COMMITTEE OF EXPERTS ON THE TRANSPORT OF DANGEROUS GOODS AND ON THE GLOBALLY HARMONIZED SYSTEM OF CLASSIFICATION AND LABELLING OF CHEMICALS

MISCELLANEOUS PROPOSALS OF AMENDMENTS TO THE MODEL REGULATIONS ON THE TRANSPORT OF DANGEROUS GOODS

Marking of Packages

Comments on paper ST/SG/AC.10/C.3/2004/26

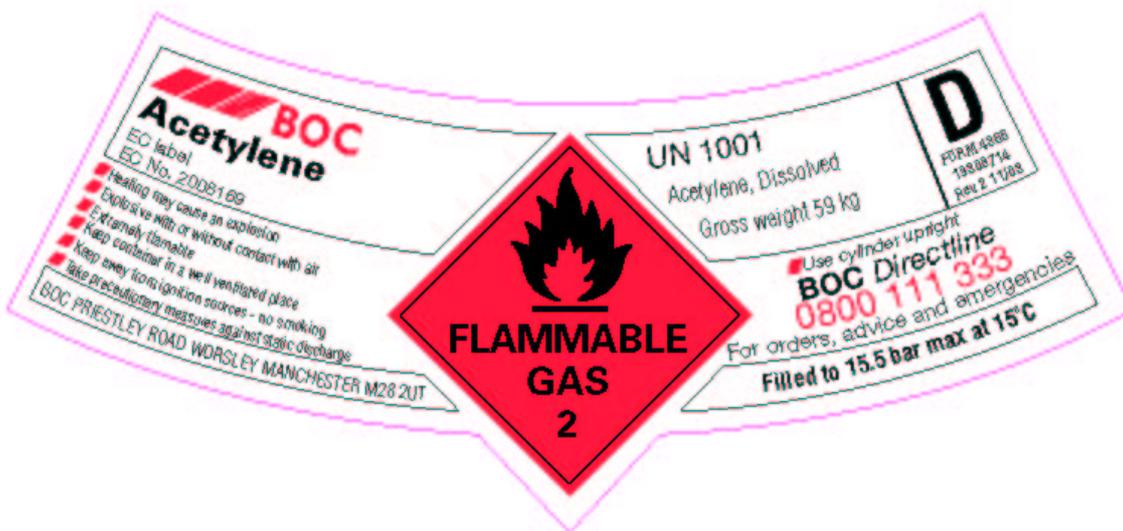
The available area for marking cylinders used for transporting gases is very small. The way cylinders are transported (generally strapped close together in pallets) means that labels on the cylindrical portion of the body would not be visible in transport and would soon become defaced and illegible. The industry has therefore used labels of a reduced size mounted on the non-cylindrical part (shoulder) of the cylinder. This practice is recognized in the Model Regulations in provision 5.2.2.2.1.2. As well as using a reduced size label, the area covered by a paper sticker has to be kept small so that the essential stamp markings are not obscured.

The amount of information required in this restricted space is large and small print fonts are a necessity. The following example of a paper sticker shows the amount of information necessary, not only for transport purposes but also to give the user information required under general product safety legislation. For reference, on this label the UN number is shown at 2.5 mm high and the company logo is 4 mm high; the label has a 30 mm square size which is larger than the 25 mm reduced size label permitted by 5.2.2.2.1.2. This particular example is taken from a cylinder having a water capacity of 30 liters and is therefore at the size where under the Swedish proposal a transition would be made from 6 mm high letters to 12 mm high. The latter size certainly cannot be accommodated and 6 mm text would be difficult to fit into the space available. EIGA therefore proposes that gas cylinders be exempted from this requirement.

“These package markings shall be of an appropriate size when shown on the non-cylindrical part (shoulder) of cylinders for Class 2 in conjunction a label reduced in size in accordance with 5.2.2.2.1.2.”
